Board of Mayor and Aldermen
July 2, 2024 Regular Meeting @ 7:00 PM

Item #: 8.C. Approve Change Order #3 with Baron Construction, LLC for the Public Works and Community Development Services Facility.

This is a change order for the construction of the Public Works and Community Development Services Facility.

A102
sheet

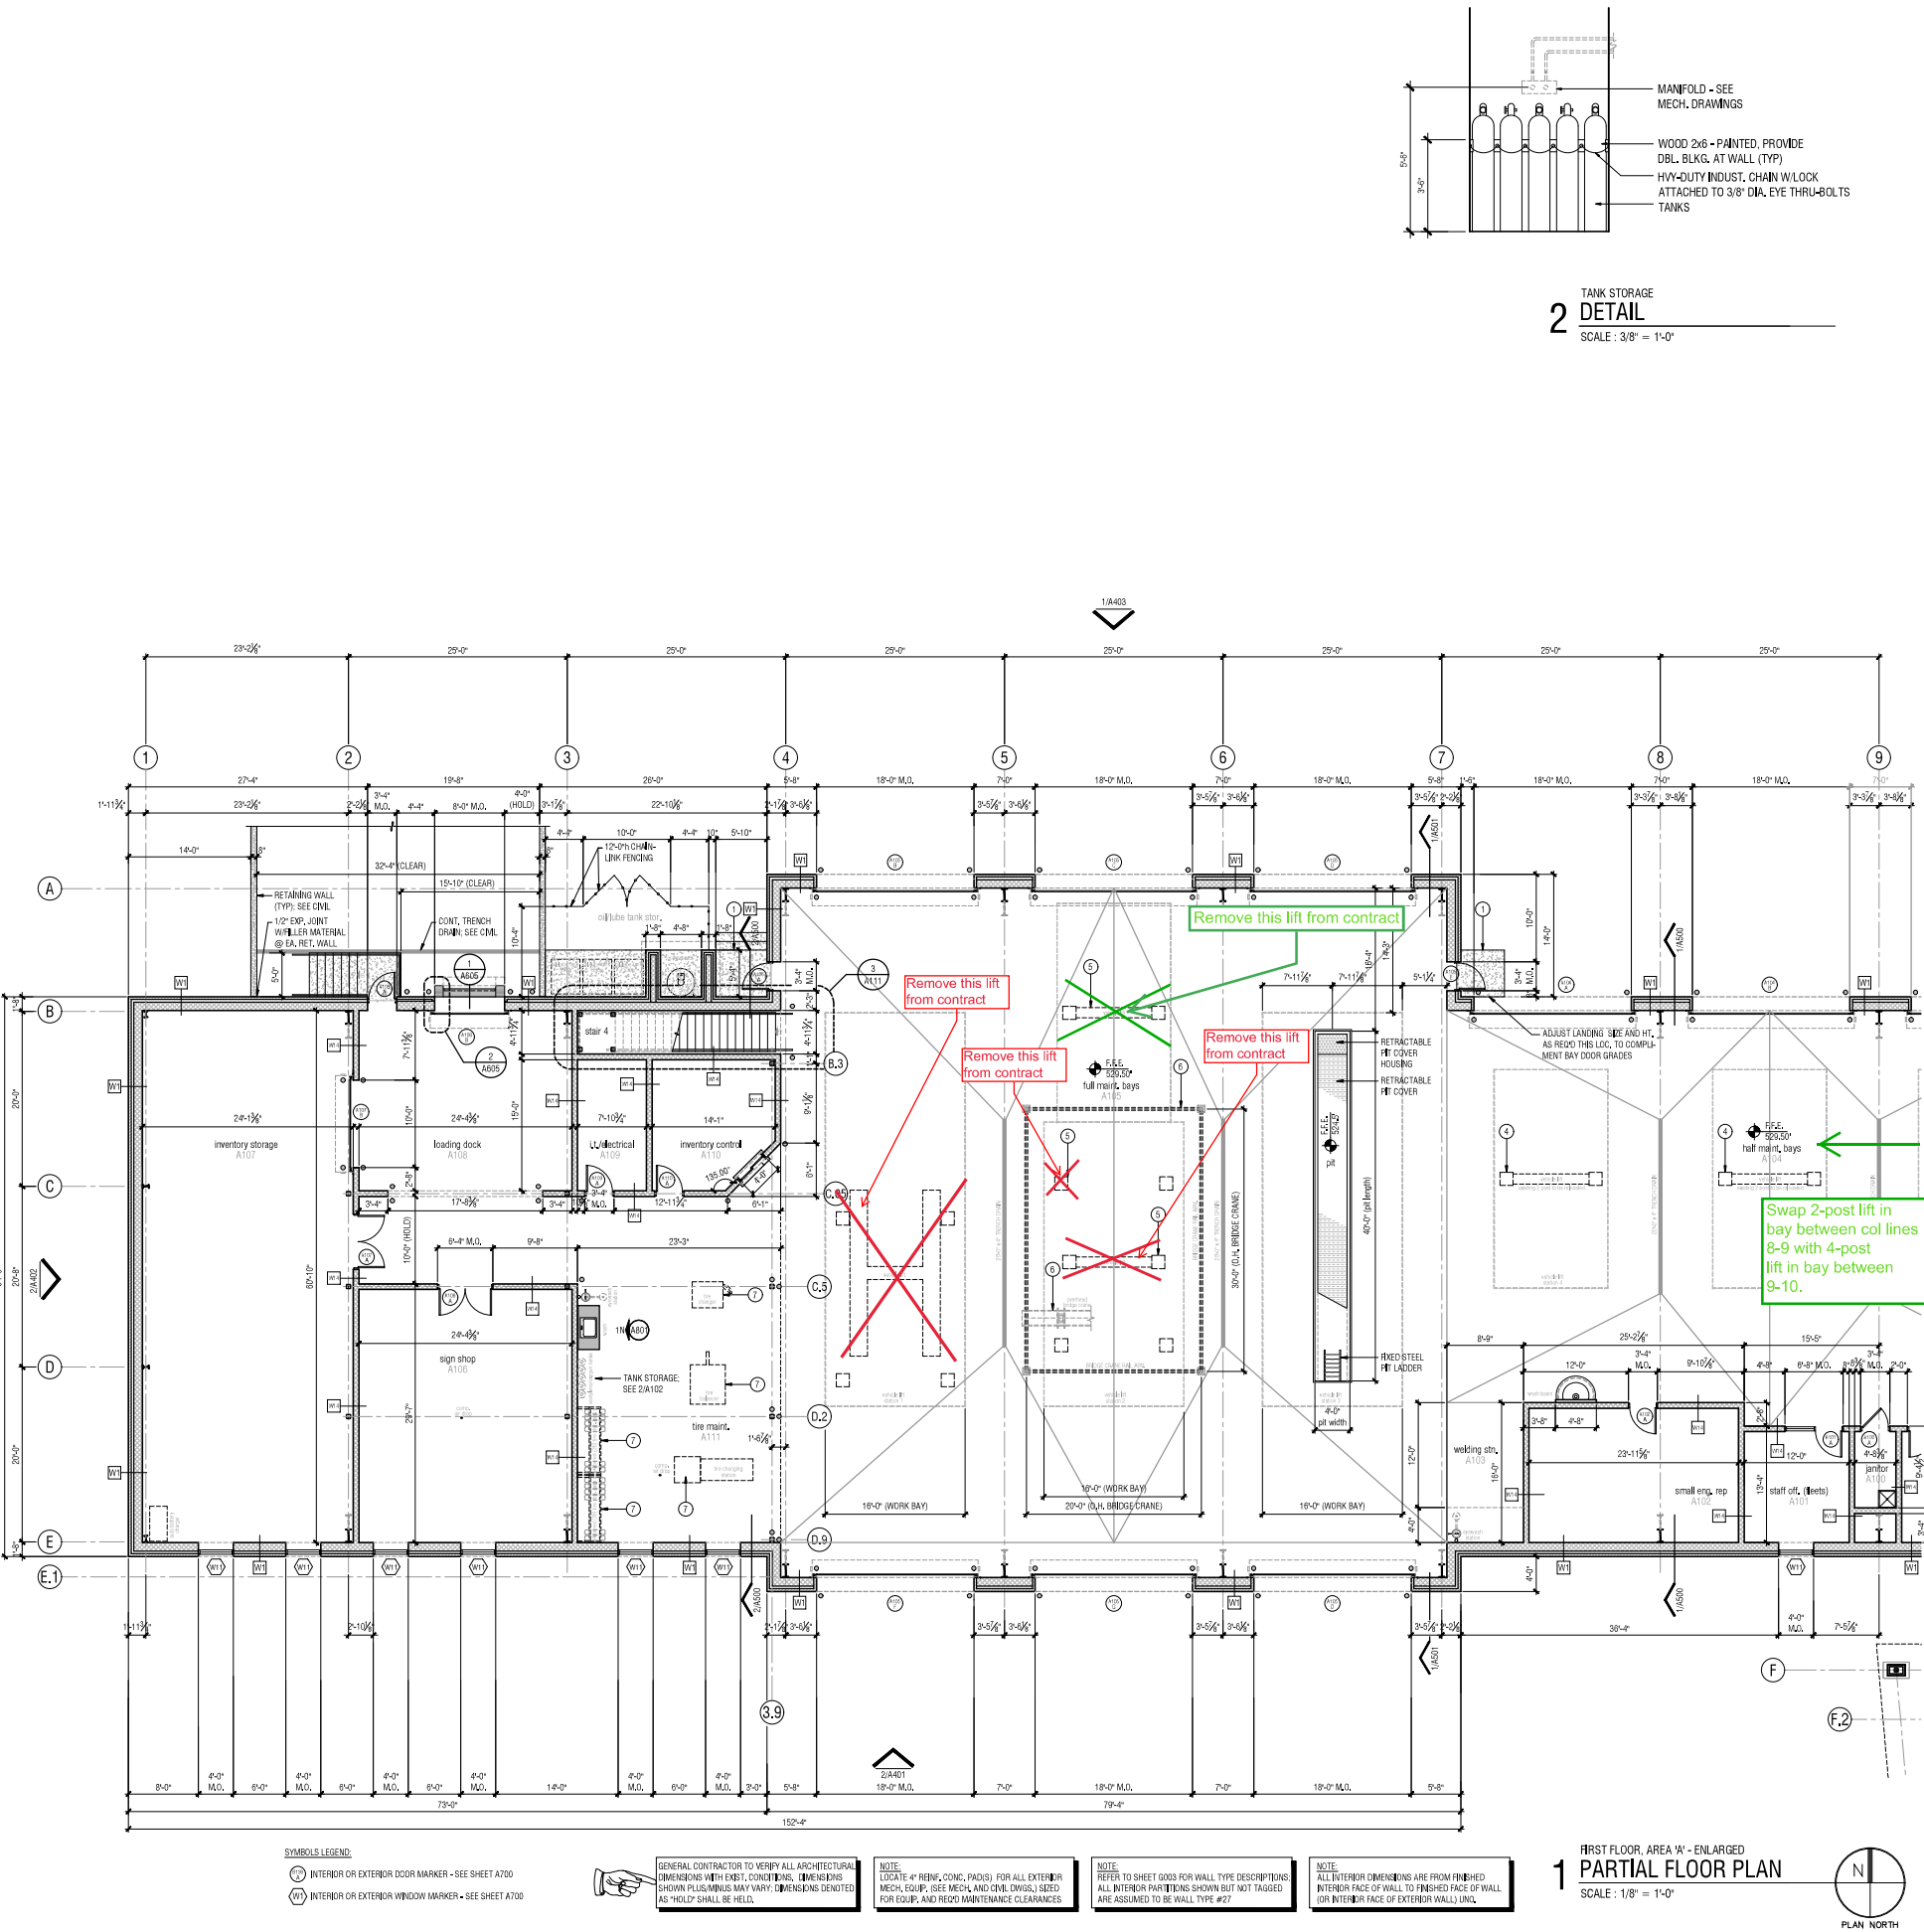
COST CATEGORY/ITEM	UNIT PRICE	QUANTITY	TOTALS	NOTES
Delete Vehicle Lifts				
Credit for 4-Post Lift Installation	\$ (1,200.00)	2.00	\$ (2,400.00)	Credit for the install of 4-post lifts removed from scope per attached markup
Credit for 2-Post Lift Installation	\$ (850.00)	2.00	\$ (1,700.00)	Credit for the install of 2-post lifts removed from scope per attached markup
SUBTOTAL			\$ (4,100.00)

Drawing Number(s): A102

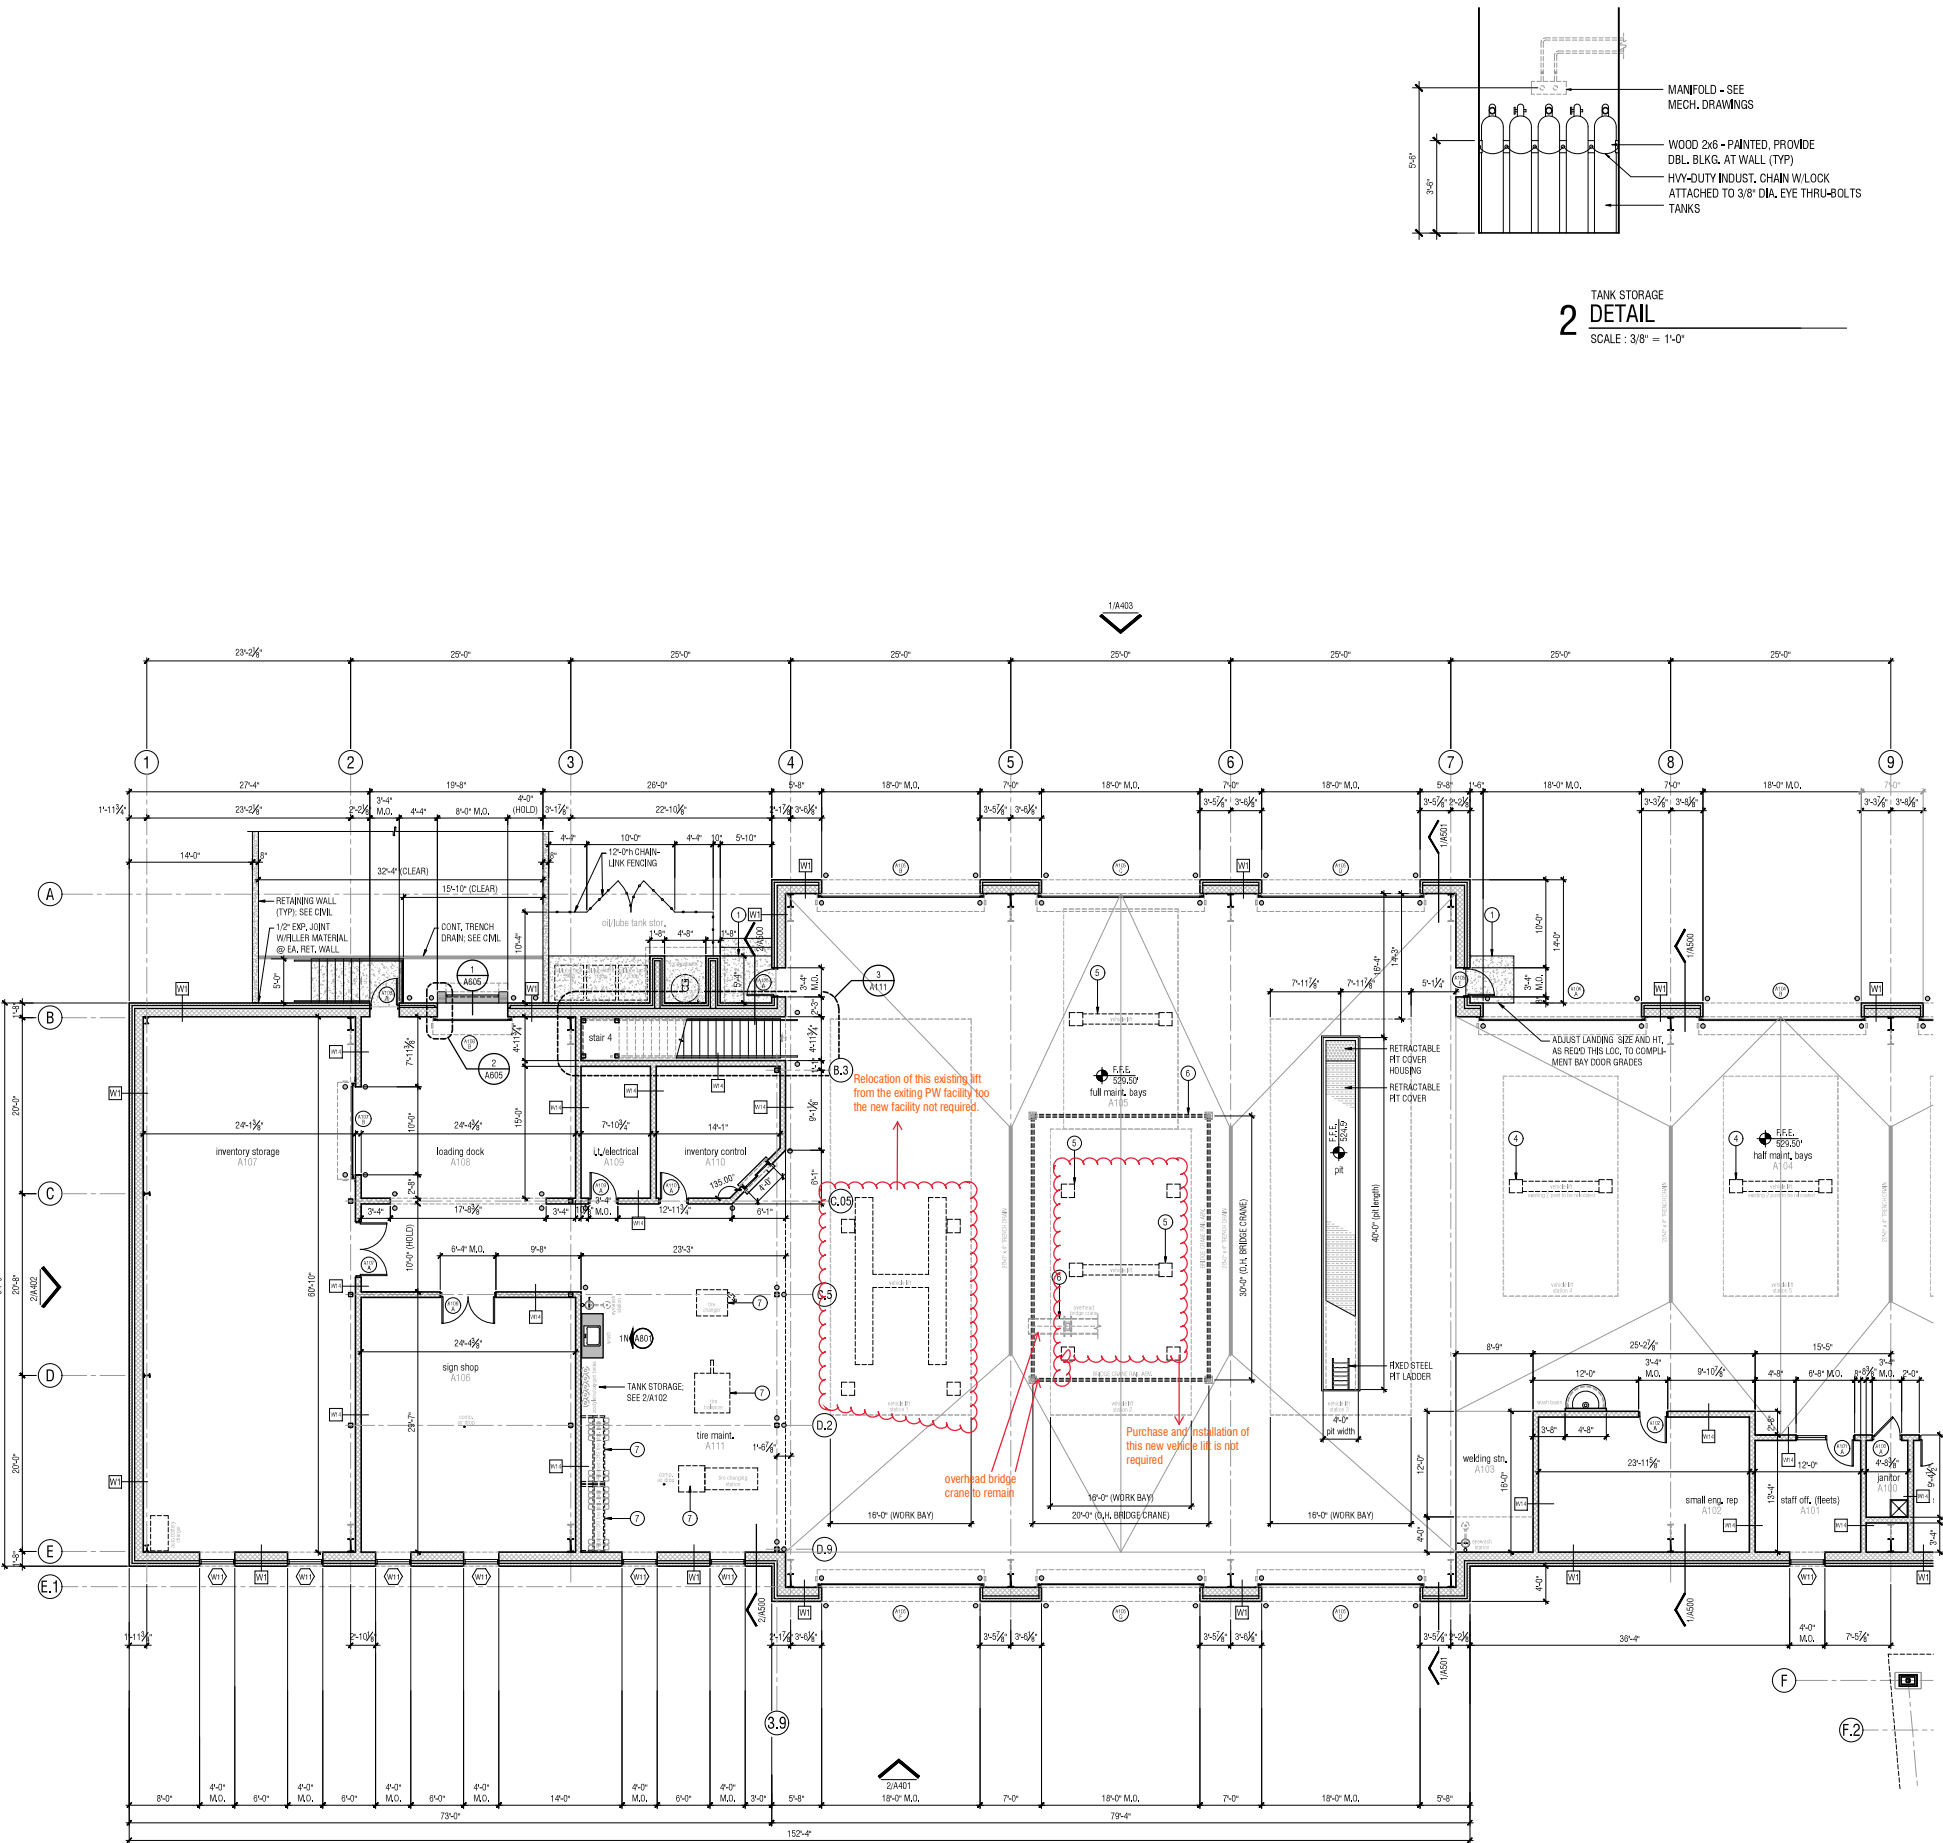
Description: Delete Vehicle Lifts

DELETE: Please provide a credit to delete the labor and all associated costs to relocate the existing lift from the existing PW facility to the new facility as shown on the attached drawing (*sheet A102*), and the labor, equipment, and associated costs to furnish and install the new vehicle lift as shown on the attached drawing (*sheet A102*).

NOTE: Electrical and/or other utilities feeding these lift locations shall remain as specified under the Contract Document

AREA A - ADDITIONAL
UNDERCUT/BACKFILL OVER
PREVIOUS RFC 15 QUANTITIES

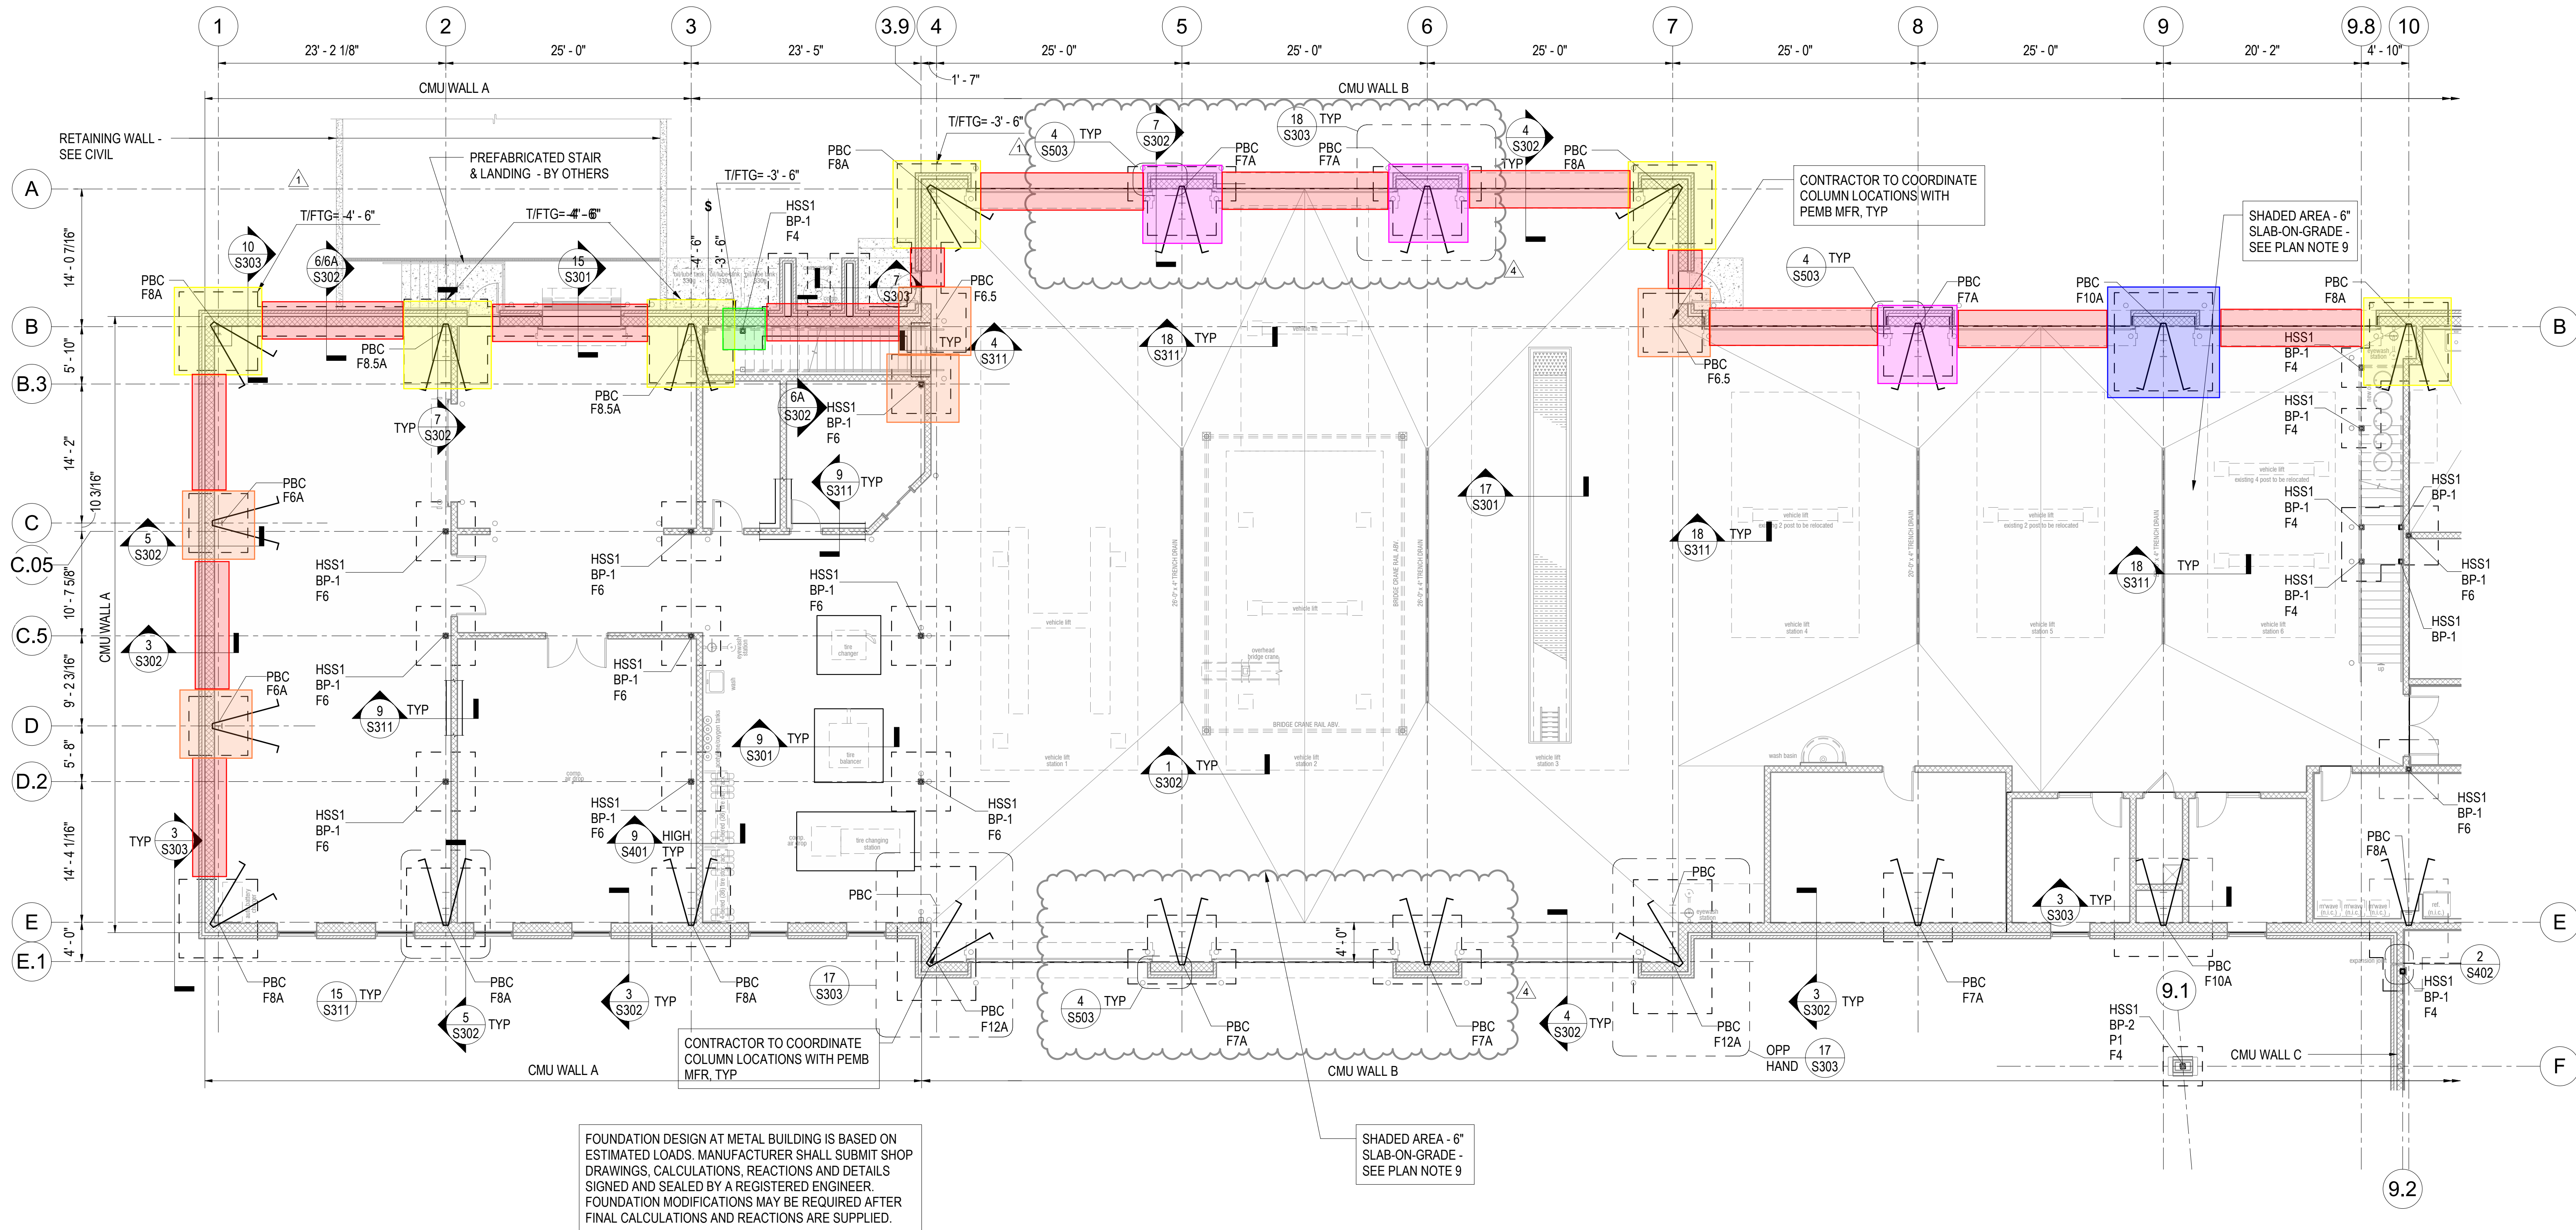
Footer Undercut & Backfill in Area B, and additional in Area A (over previously submitted RFC 15 quantities). Undercut and backfill with approved fill under supervision of TTL Technician on site, per TTL reports and CEC email recommendation/directive. This includes the eastern end of Area B where modified detail E-16 was used with additional concrete thickness below bottom of footer elevation

4/1/2024	B/17	F8A footing. Undercut down to 12' below FF (8'-6" below footing)	11.00	11.00	8.50	38.09	\$ 80.00	\$ 3,047.41	1	Spring. Hole grew to 11' x 11'. "Suitable Bearing Soil" not encountered, stopped at 8'-6" below bottom of footing per CEC detail E-16 sketch and emails
		F8A footing. Backfill to 5'-6" below FF (6'-6" of backfill)	11.00	11.00	6.50	29.13	\$ 24.50	\$ 713.68		
		additional 2' depth concrete	11.00	11.00	2.00	8.96	\$ 165.40	\$ 1,482.47		concrete additional 2' thickness below bottom of footer
		additional concrete at footer	1.00	57.00	1.50	3.17	\$ 165.40	\$ 523.77		concrete additional quantity due to size of excavation increased from groundwater impact. F8A footer 8'x8', actual 11'x11' difference is 57sf
	B/17 - E/17	Continuous footing undercut	32.00	3.00	1.00	3.56	\$ 80.00	\$ 284.44		61' length, less the spread footers = approx 32' total length
		Continuous footing backfill	32.00	3.00	1.00	3.56	\$ 24.50	\$ 87.11

Confirmed. Based on what we are dealing with, this will be a "ground Improvement" tactic. The stress bulb created uses Bousinesq theory to dissipate the load. Tyler is familiar and this is the plan if the firm ground is not "visually" identified. This will need some judgement applied by Tyler and us to help get them out of this mire.

The detail we provided should be the option to move forward with for the exterior foundations based on our understanding of the site condition. Tyler can work with me or Emily directly if his personnel encounter bearing soils below design at the base of the excavation. The basic plan is to place the stone and pound it with a hoe-pack at the base of the excavation to achieve suitable bearing. This can be brought up in lifts to the base of the concrete.
